# Agenda HISTORIC DISTRICT COMMISSION

Regular meeting 6:30 p.m. August 6, 2025 Board Meeting Room of Town Hall Annex, 105 E. Corbin St.

#### ITEM #6. A:

#### ITEM #6. B:

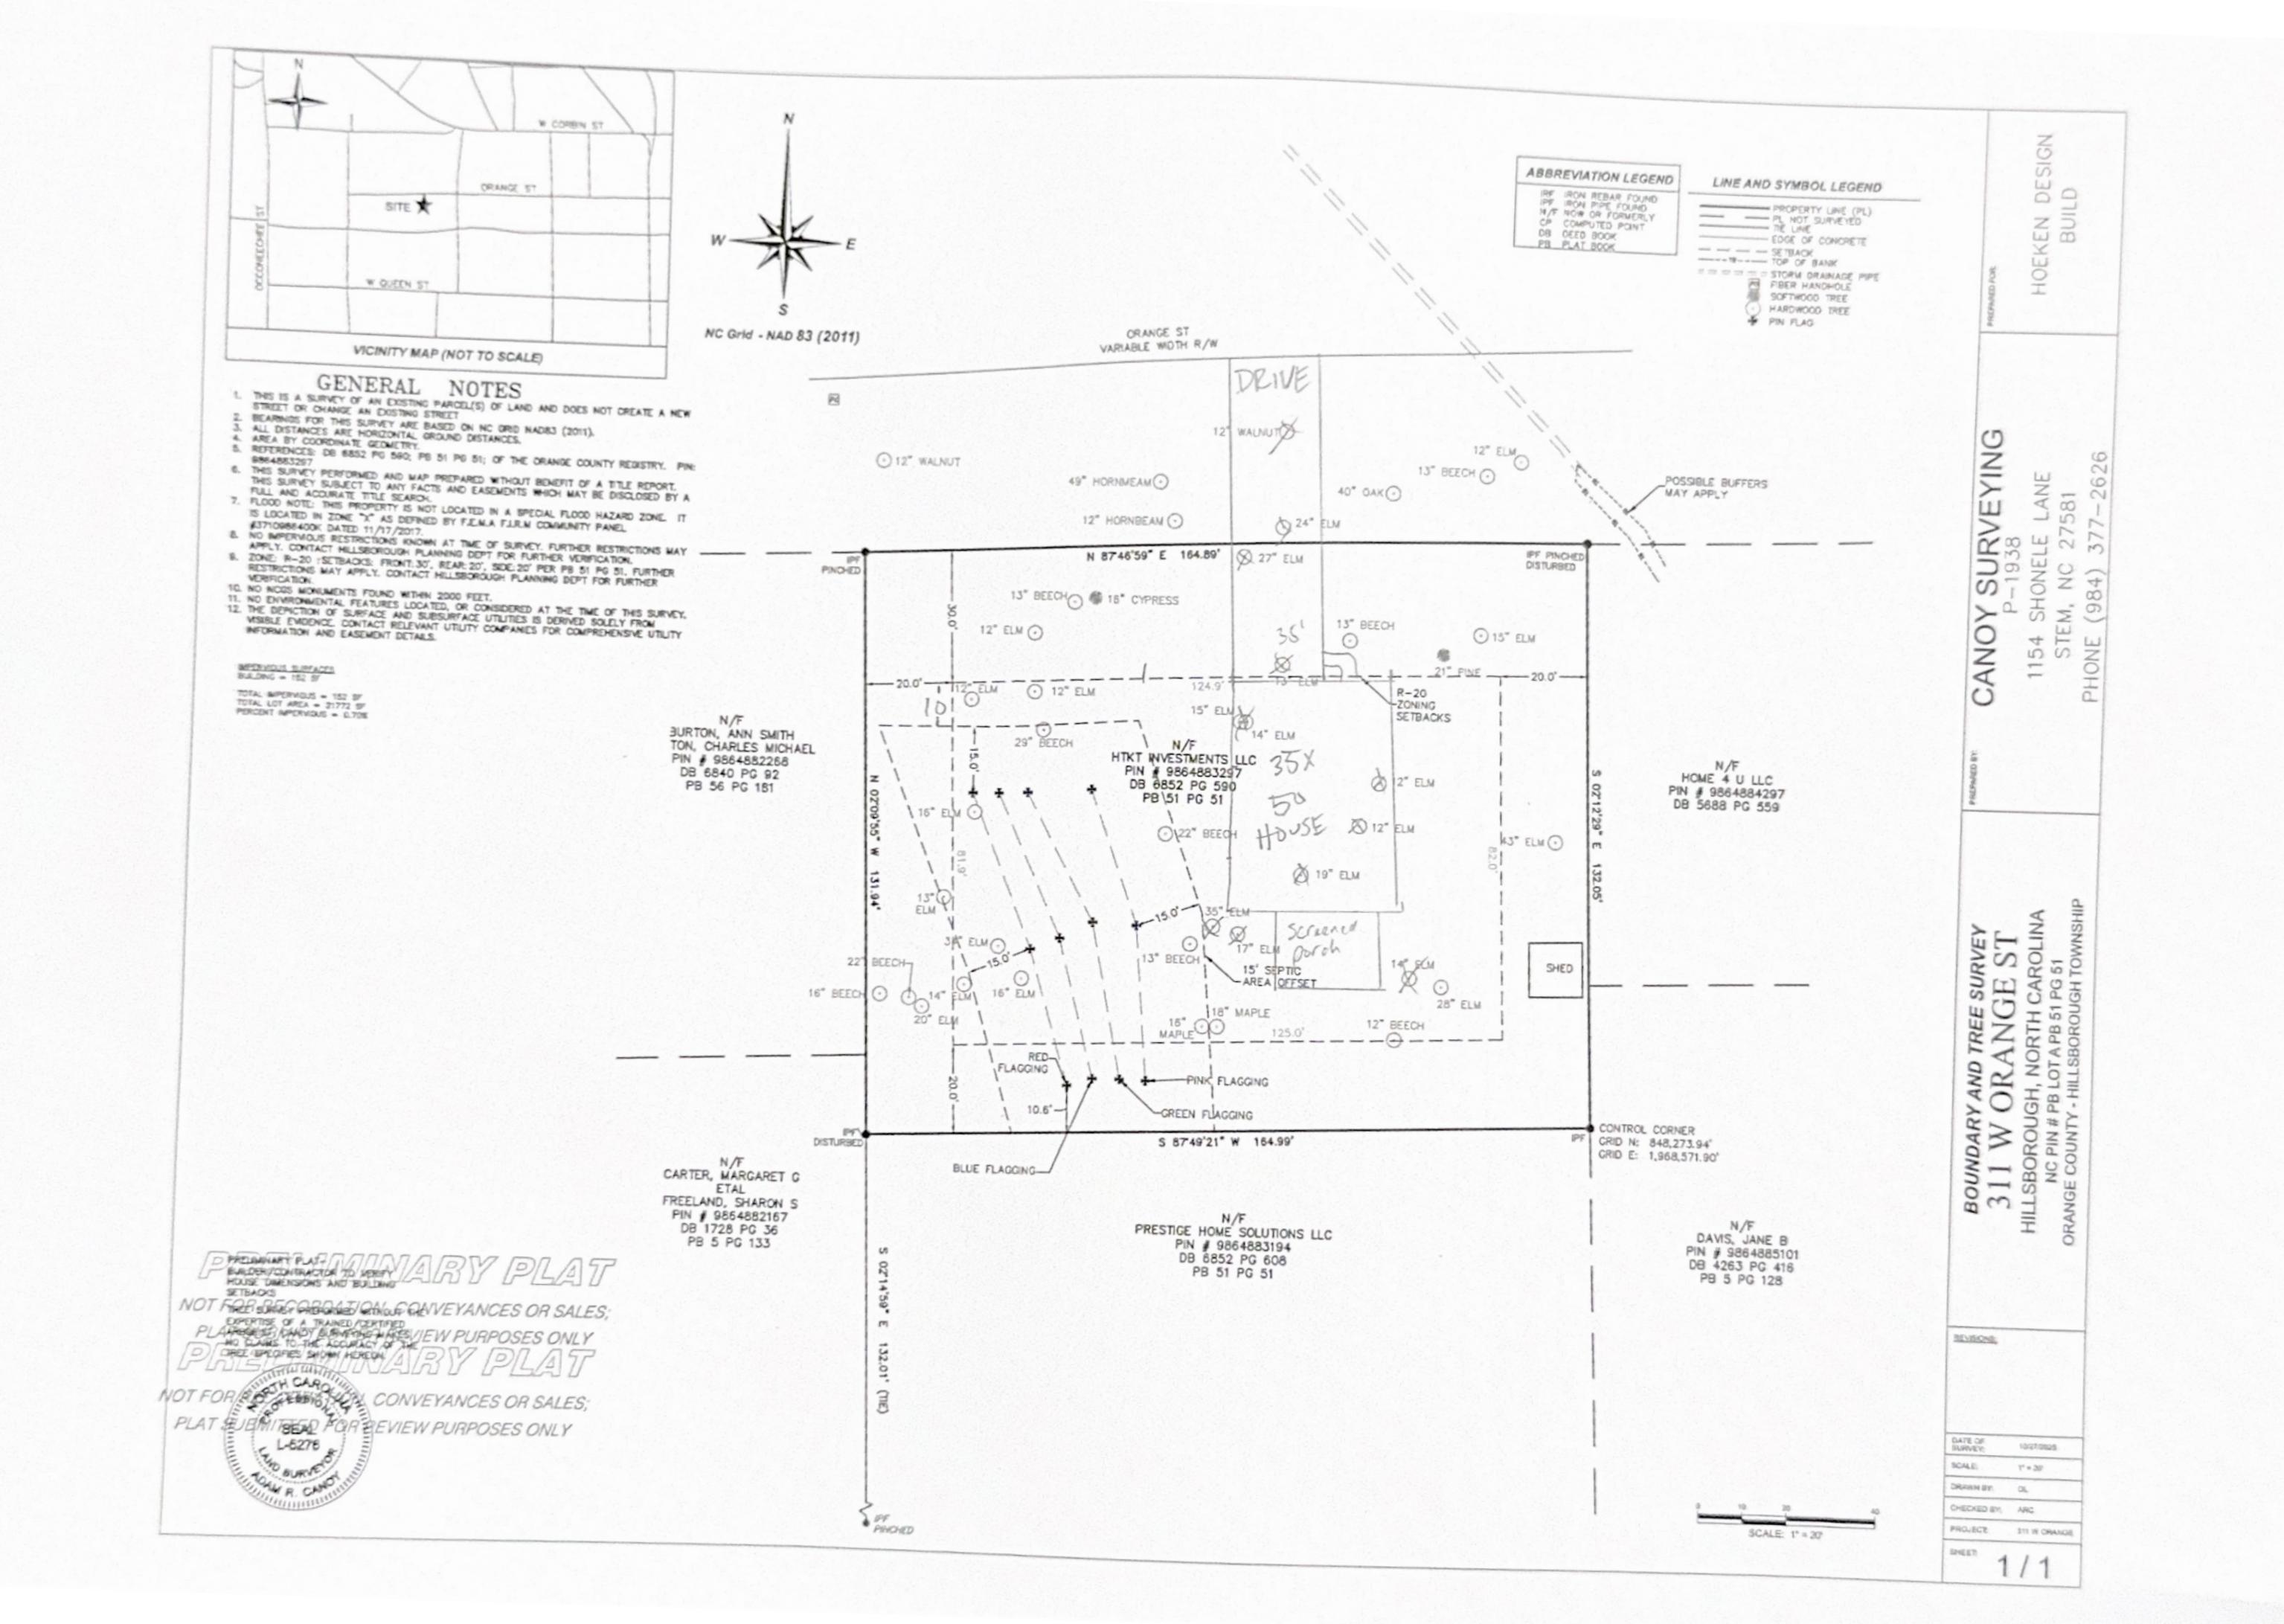
- The site plan appears to indicate that four trees with diameters over 24 inches will be removed for construction of the house, and one will be removed for the septic drain field.

# **ELEVATION 1**

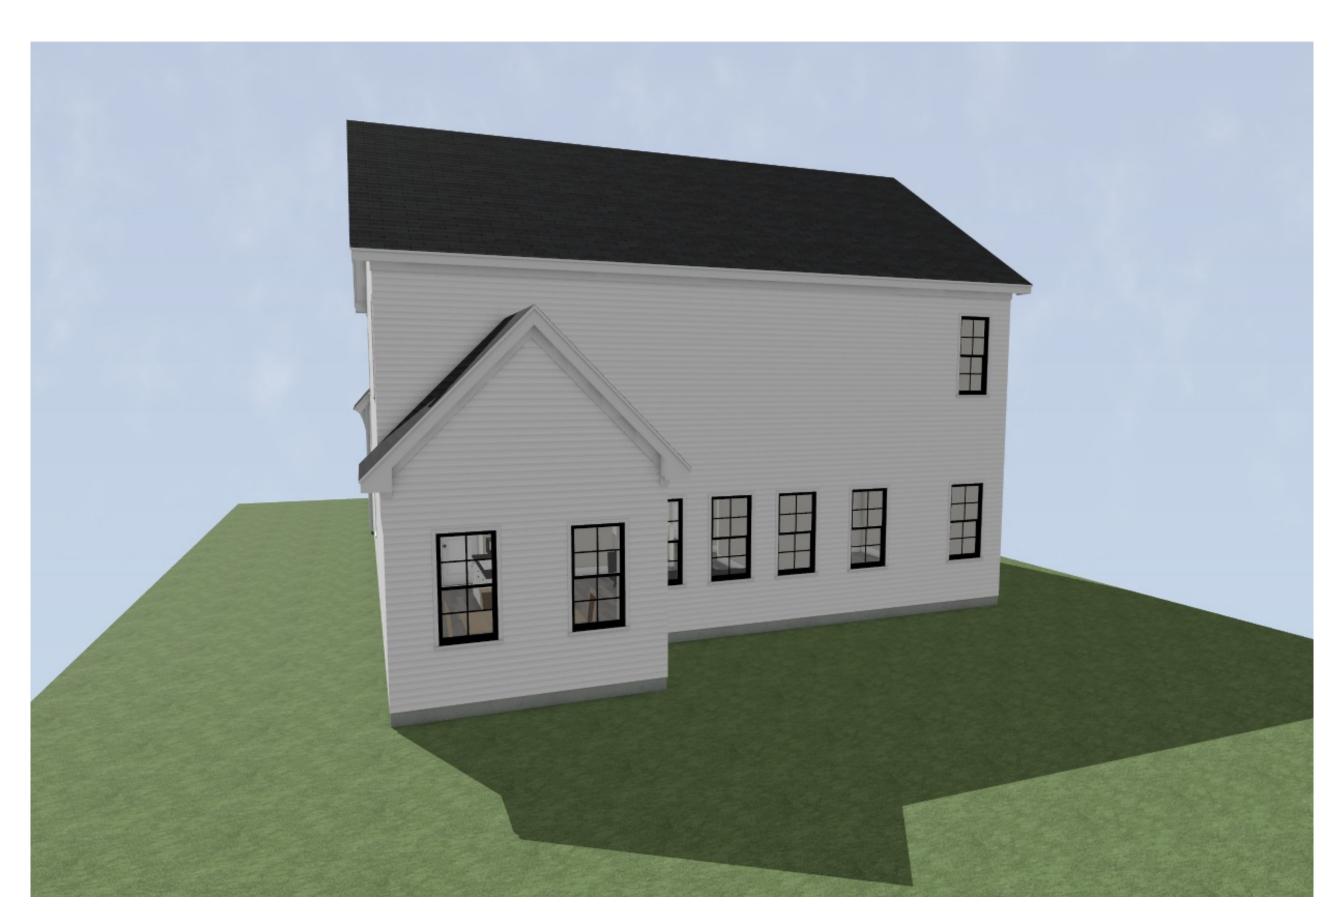
- The design standards prohibit painting historic brick but do not restrict painting new brick.
- The approximately 30-foot height of the roof is taller than the roofs of the adjacent houses. The new house at 320 B W. Orange St. that the HDC recently approved has a similar roof height but is set back further from the street.

- The roof pitches for both street-facing gables are relatively narrow in comparison to most roof pitches in the historic district.
- The application describes the design as reminiscent of houses from the early 1900s. The HDC is tasked with evaluating the proposal's compatibility with the historic district rather than what general era the design is intended to evoke.

- There are scattered examples of street-facing garages in the historic district, but staff are
  not aware of any existing garages that extend in front of the front line of the house or
  comprise as much of the front elevation as the proposed design does.
